GEORGETOWN-SCOTT COUNTY PLANNING COMMISSION

AGENDA

August 9, 2018

Staff Report to the Georgetown-Scott County Planning Commission

LANDSCAPING PLAN
C7.0

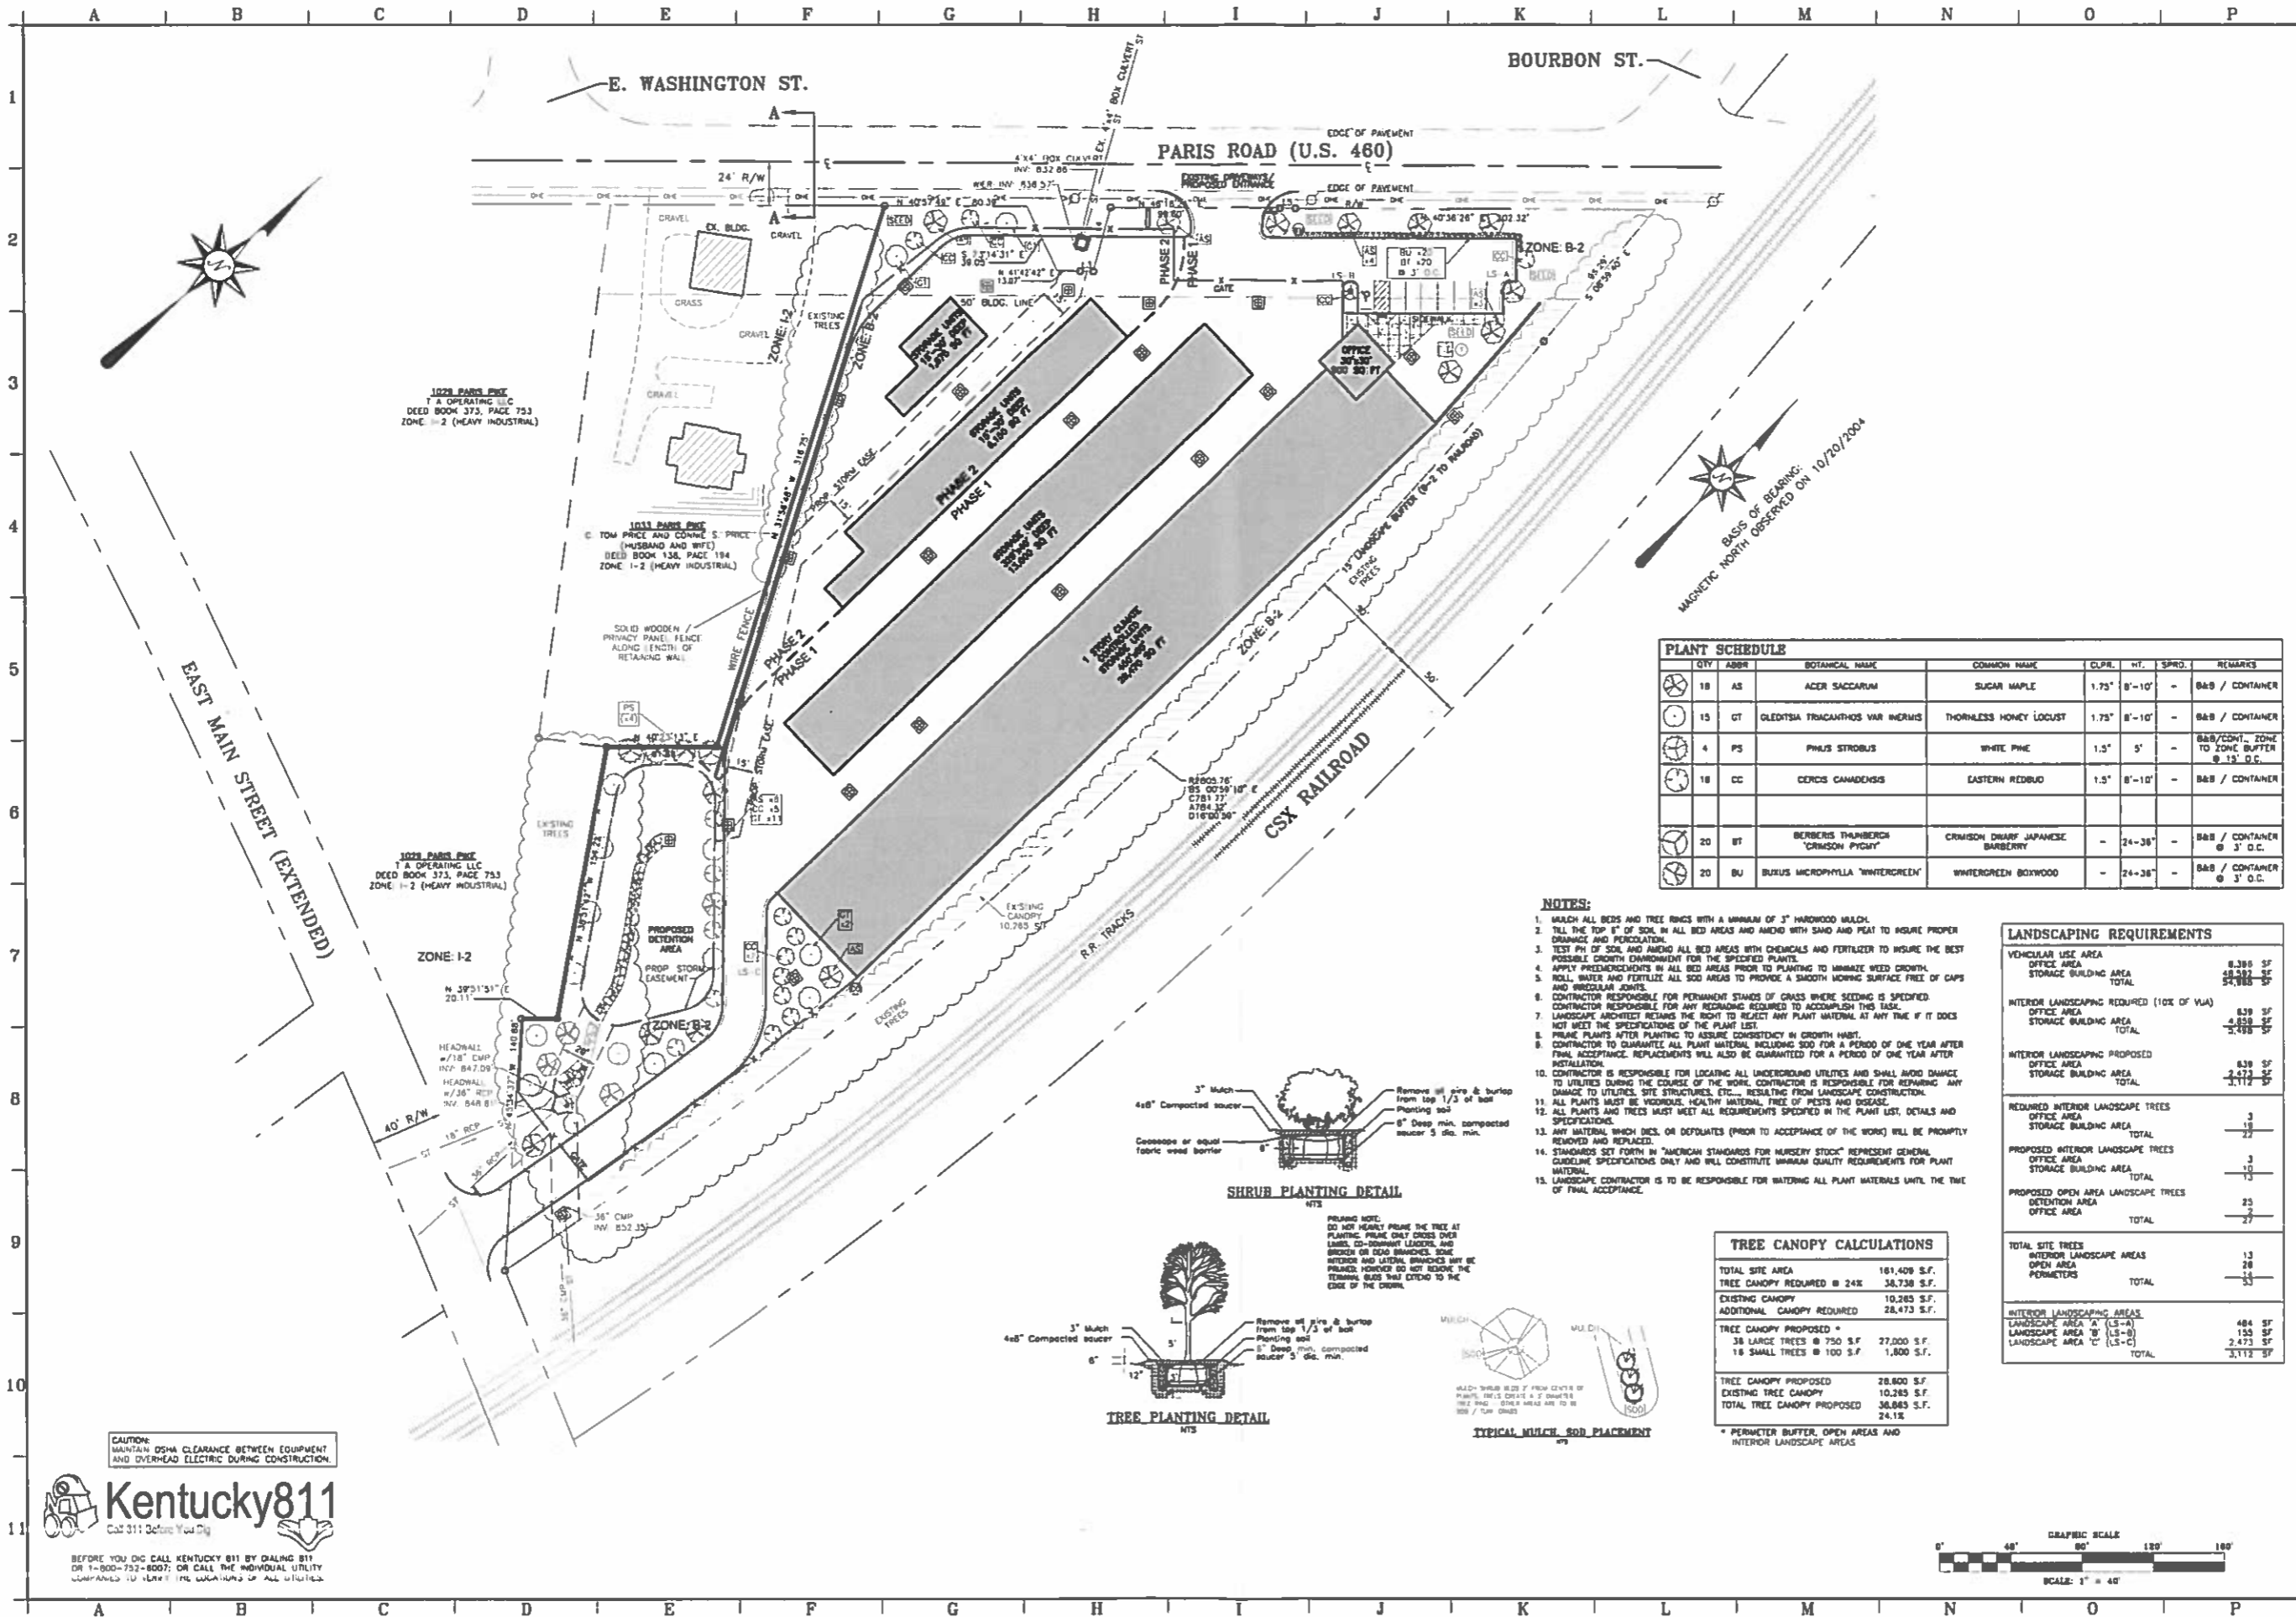
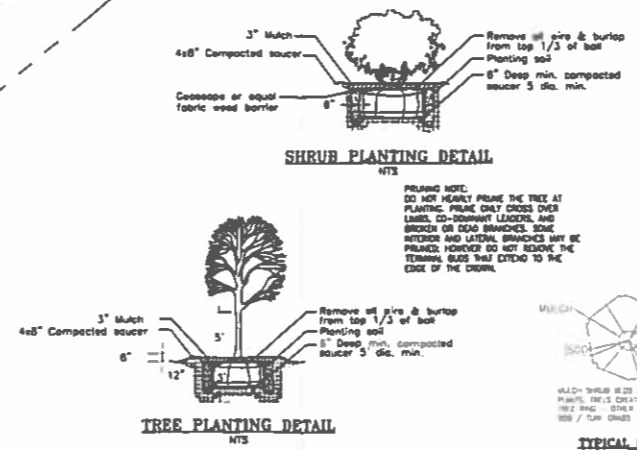
- The Applicant is proposing a combination of trees and wooden privacy fencing between the Project Site and the adjoining western property. There is a section of this buffer, where trees are not proposed due to a retaining wall on the property line. If this Final Development Plan is

approved as drawn, this will require a waiver from the Planning Commission. Staff supports this waiver because the Applicant is working in a tight window, when factoring in the storm sewer easement, building locations, and the proposed fence.

For the 3.52-acre site, a total canopy coverage of 36,799 square feet is required (24% new canopy). A total of 53 trees are being provided. The combination of trees the Applicant is proposing will provide 38,865 square feet of canopy coverage.

1. Waive the trees required along the retaining wall as shown on the Landscaping Plan.
2. Reduce the interior VUA landscaped area from 5,498 square feet to 3,112 square feet, and allow 9 of the interior VUA trees to be planted elsewhere on the Project Site.

PROJECT TITLE: PRELIMINARY LANDSCAPE PLAN

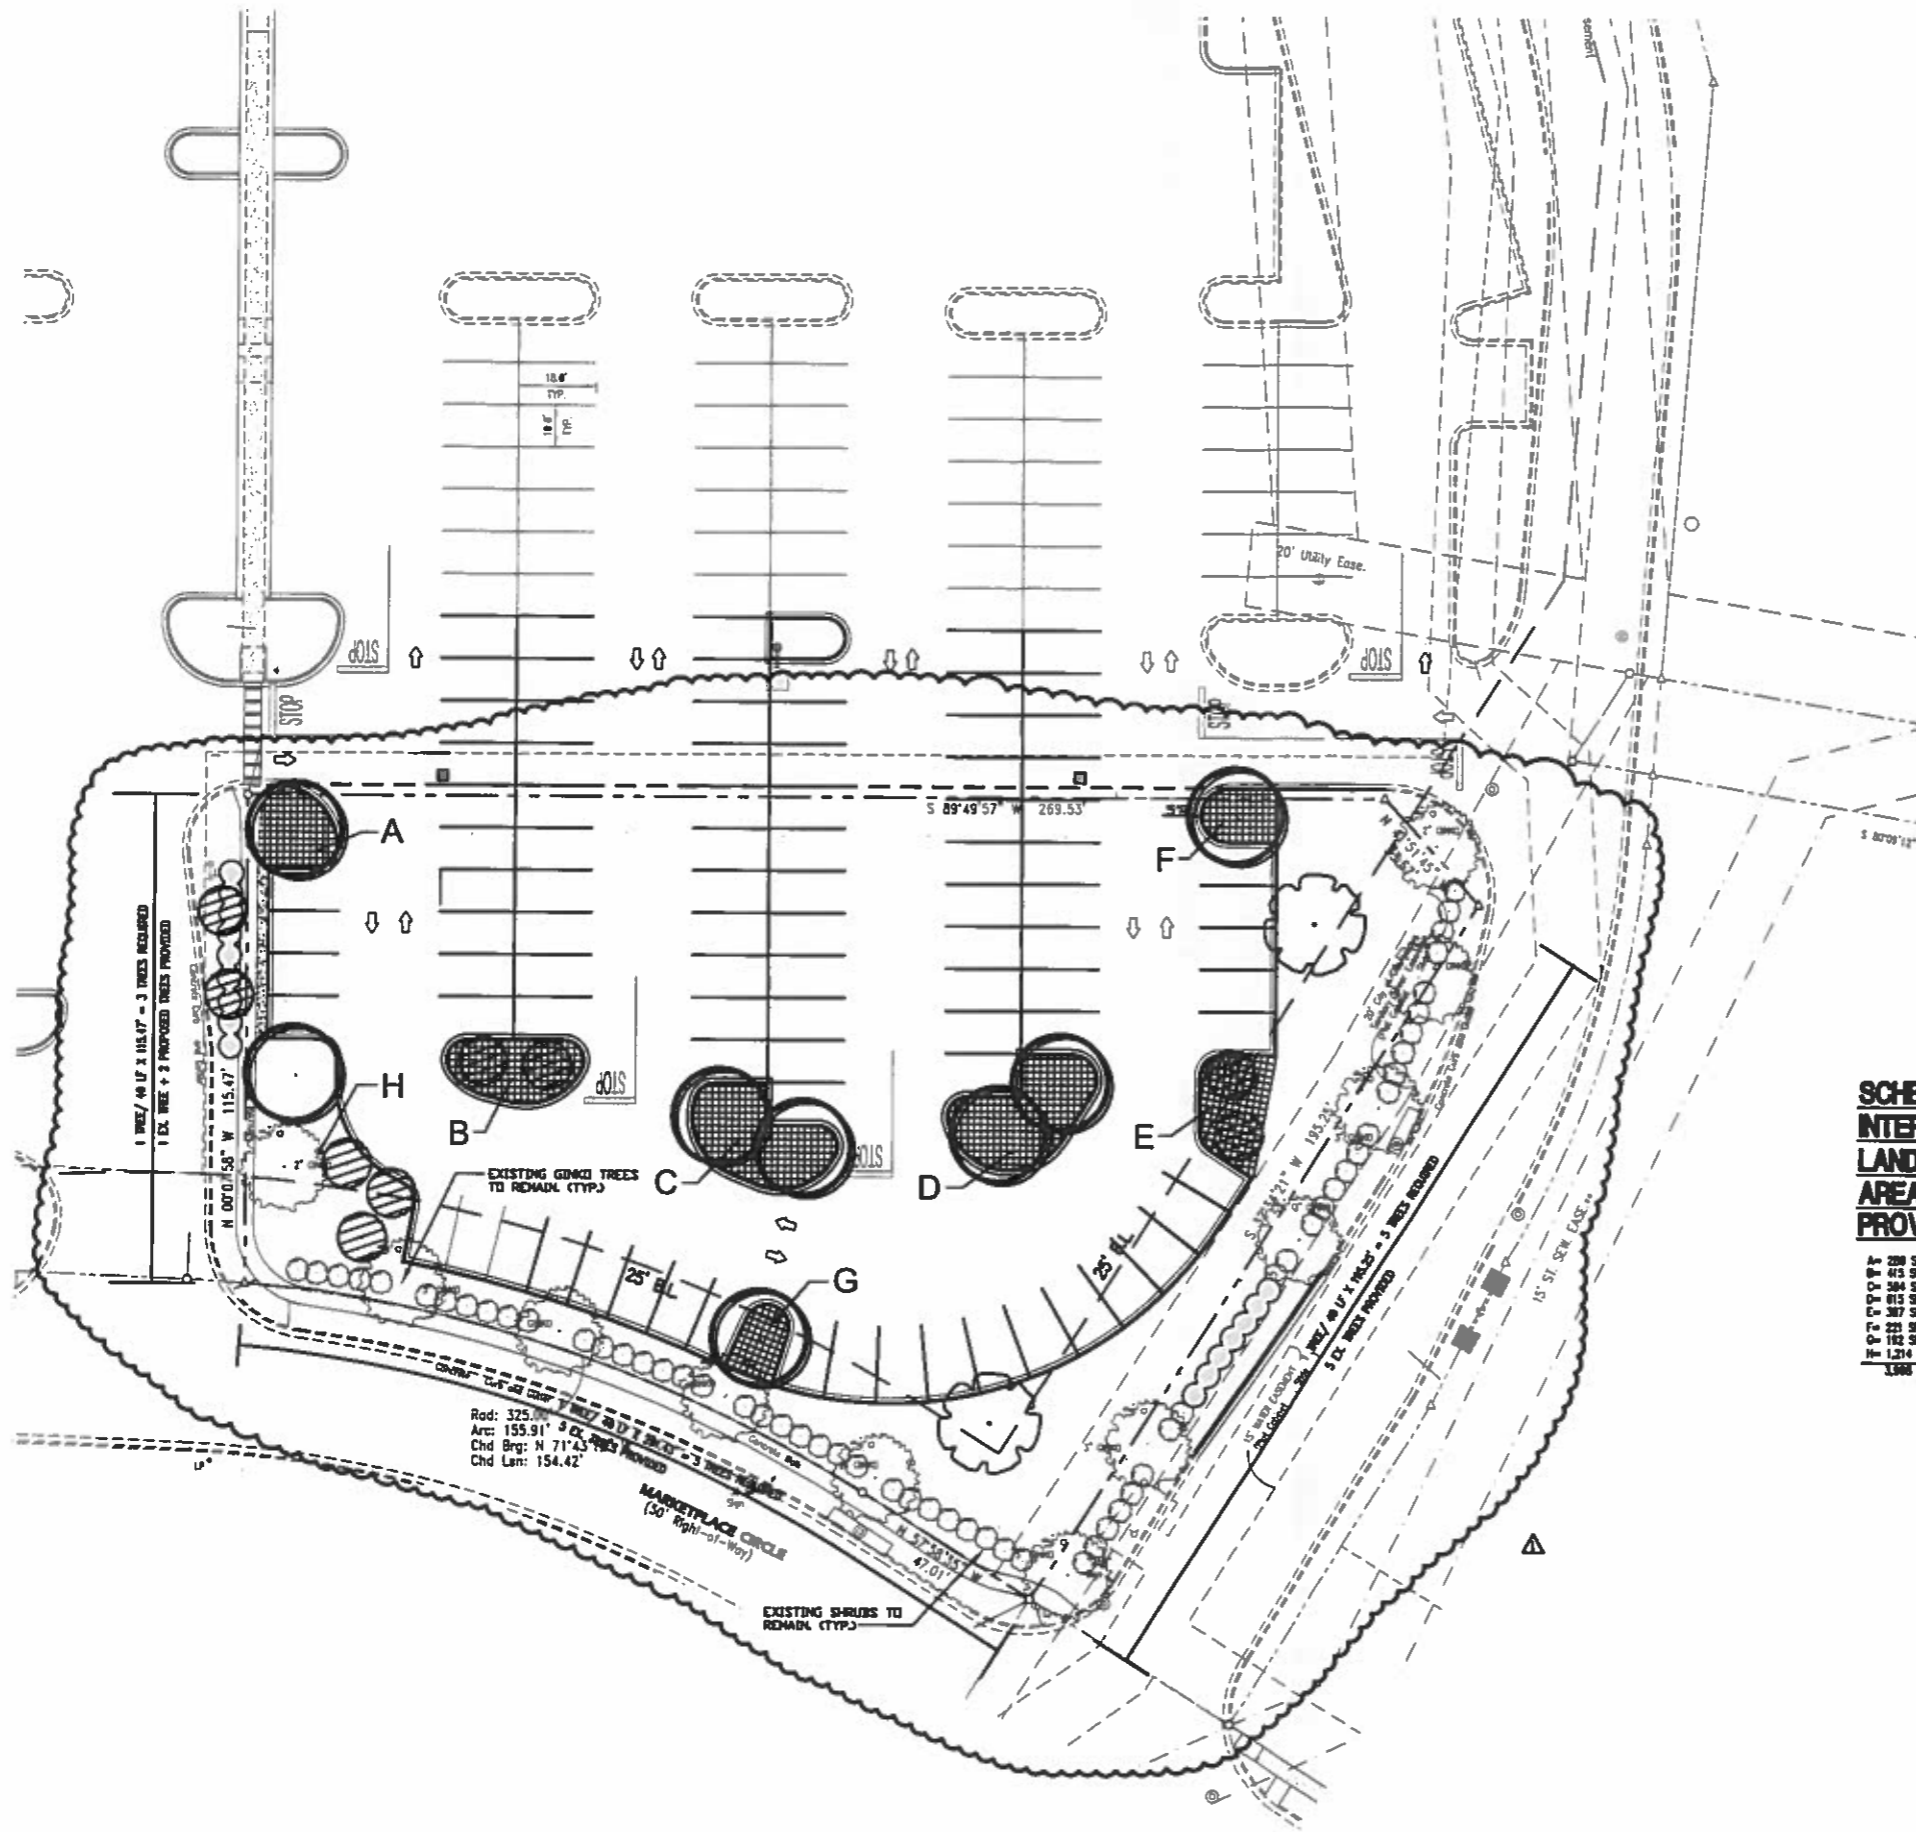
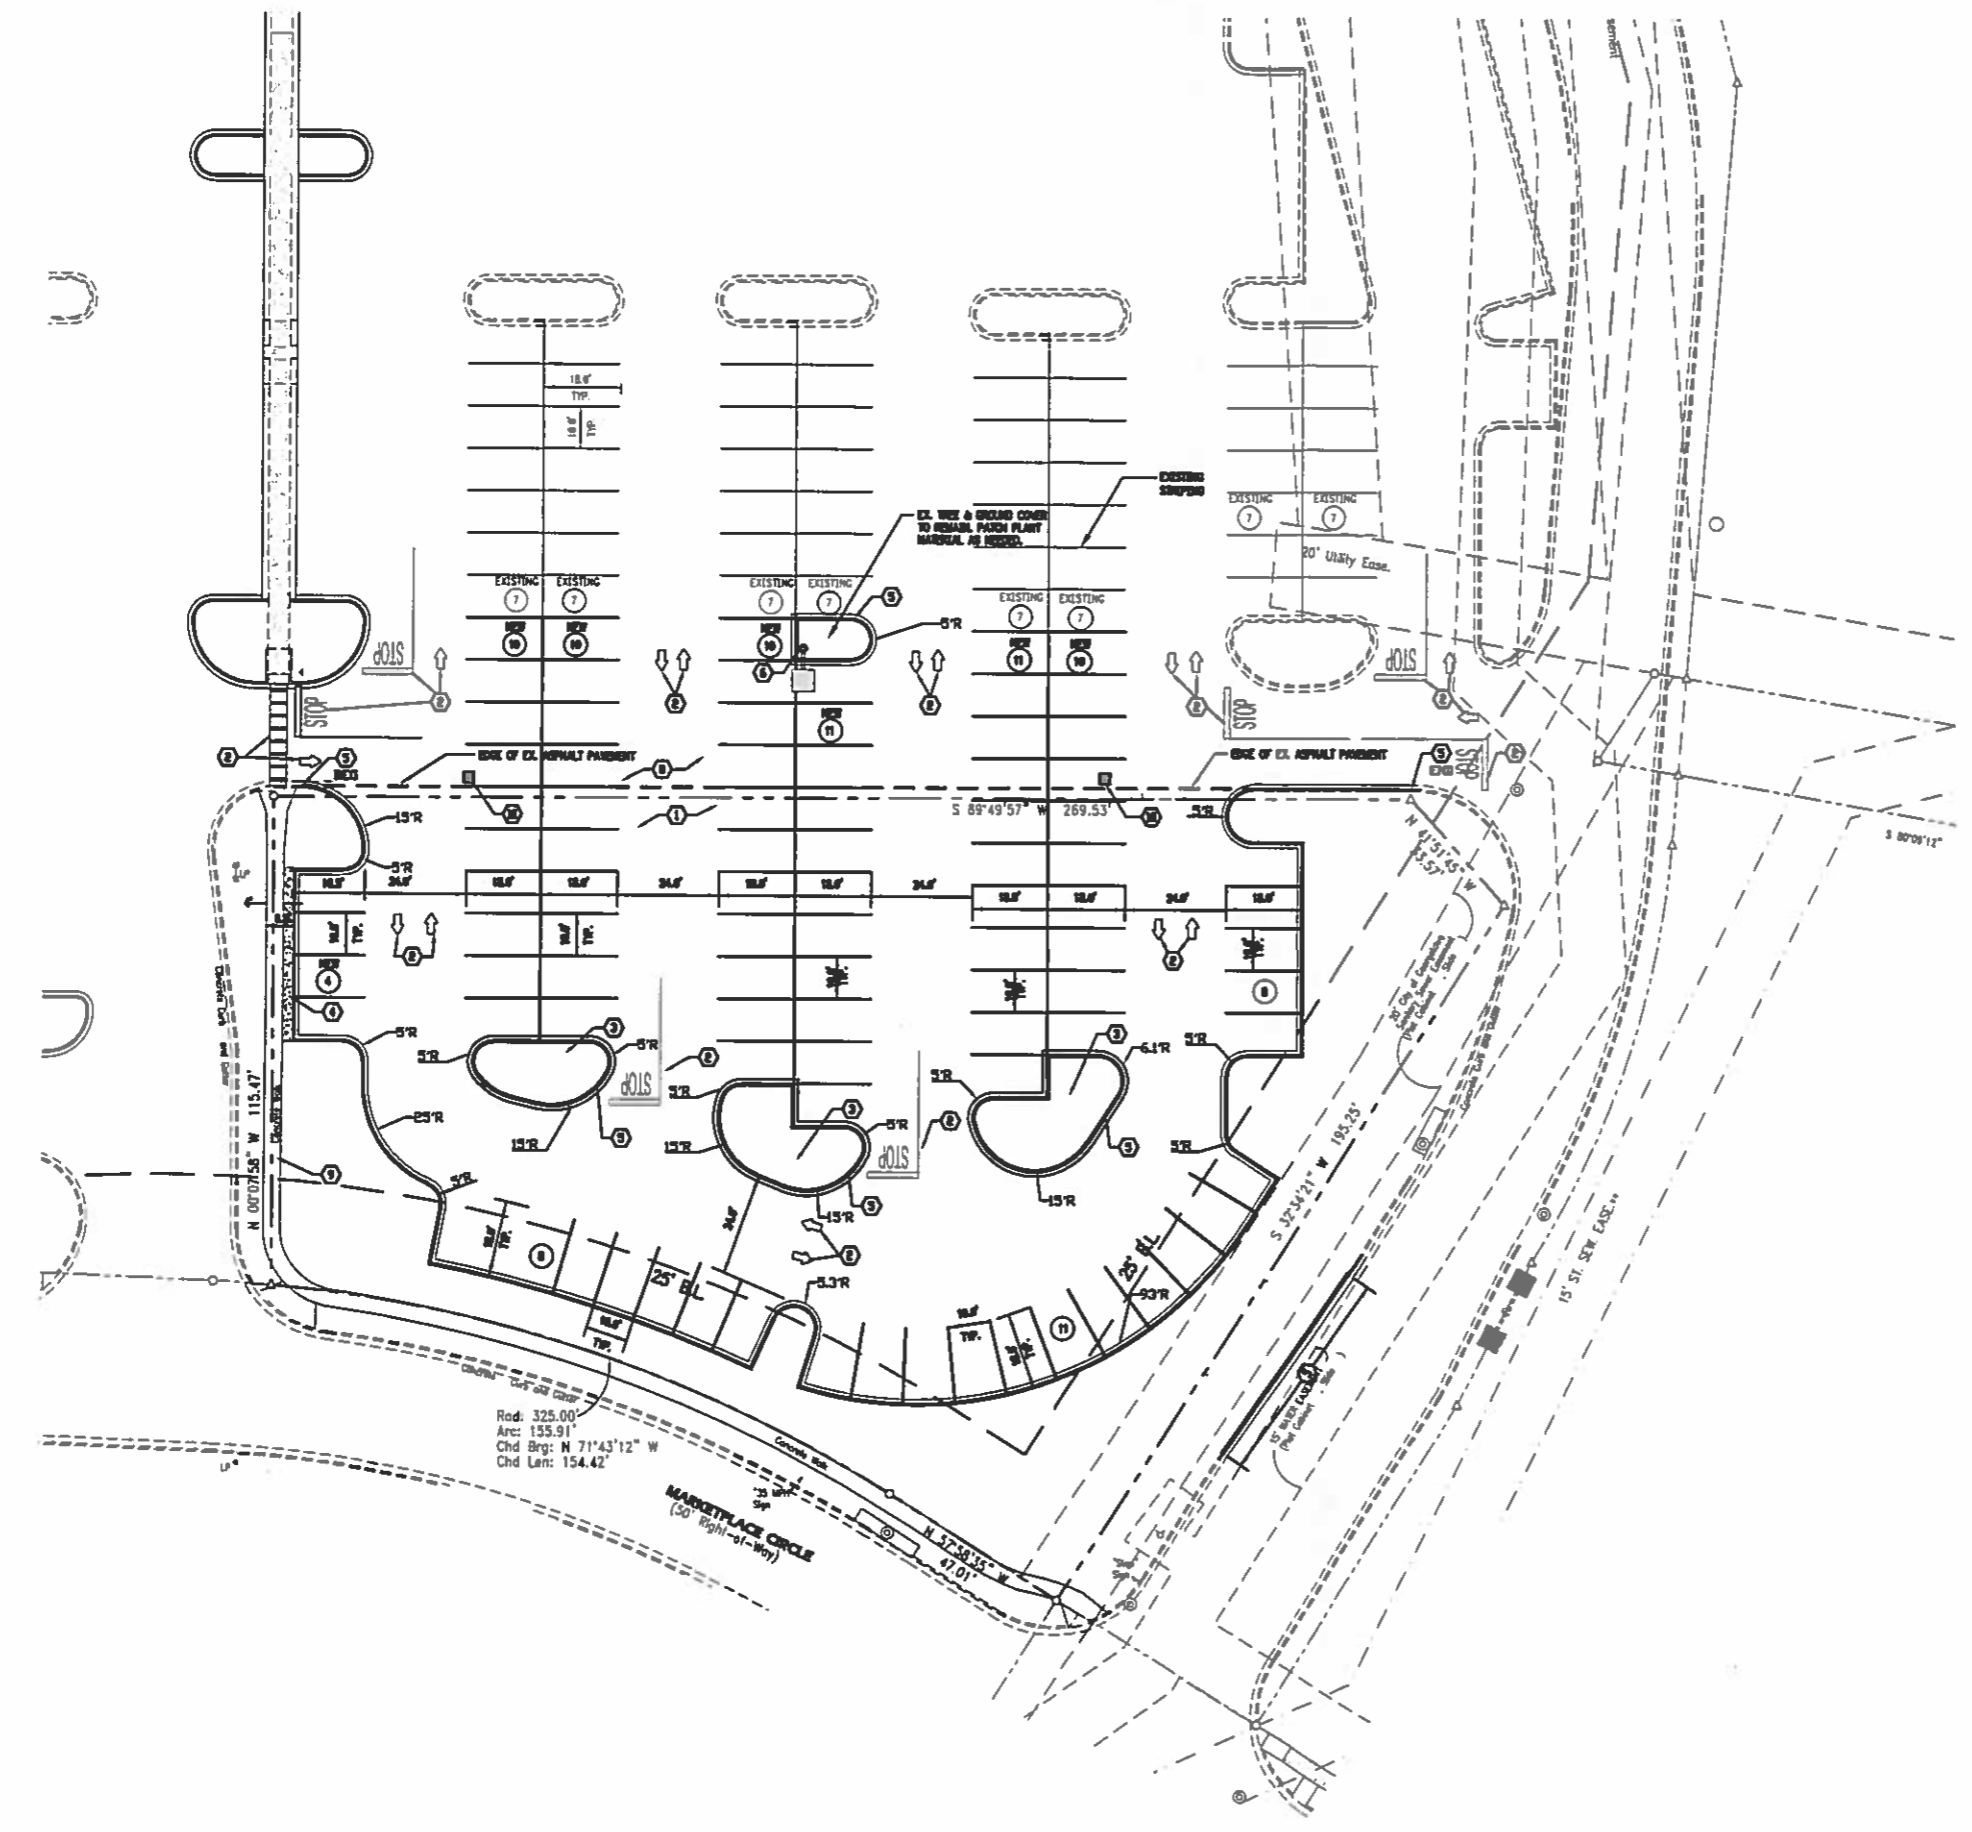
The proposed plan meets the requirements for interior vehicular use area landscaping. The Preliminary Development Plan proposes increasing the parking lot area by 37,617 square feet. The parking lot expansion requires at least 3,752 square feet of interior VUA landscaped area. The Applicant is proposing 3,908 square feet of interior VUA landscaped area. The Applicant is showing the required 15 trees for this landscaped area.
